Technical Bulletin

Number: 058
Date Issued: 11/15/06
Expiration Date: None

Subject/Key Words:	Genius I/O PCI Card (PN 228699-001) DIP Switch Settings			
Classification:	<input checked="" type="checkbox"/> Informational	<input type="checkbox"/> Mandatory	<input type="checkbox"/> Safety Alert	<input type="checkbox"/> PM Impact
	<input type="checkbox"/> Warranty Impact	<input type="checkbox"/> Purchase Parts	<input type="checkbox"/> No Charge For Parts expires ___/___/___. Reference this TB# when ordering NC parts.	
Applicable Akrion Procedures:	Procedure OP2048			
Parts/Reference Documents:	Akrion GAMA Technical Bulletin 055 - GAMA Genius I/O Interface Board Reset Akrion GAMA Technical Bulletin 057 - Must have correct tool software to run GAMA computer upgraded with Genius I/O PCI cards

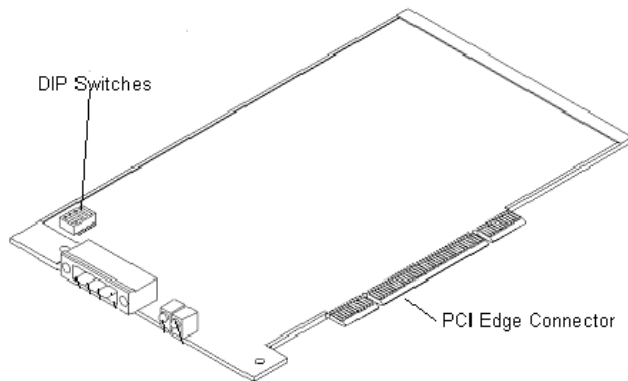
The OEM manufacturer may ship PCI cards with DIP switches in the ON position. Genius I/O PCI cards used in GAMA wet station computers must have the four DIP switches on the card set to the OFF position. Not having these set to OFF changes the bus impedance. This can lead to IO faults or damage to the IO system hardware.

Before installing the PCI card ensure all DIP switches are set to the OFF position. Refer to Akrion procedure OP2048.
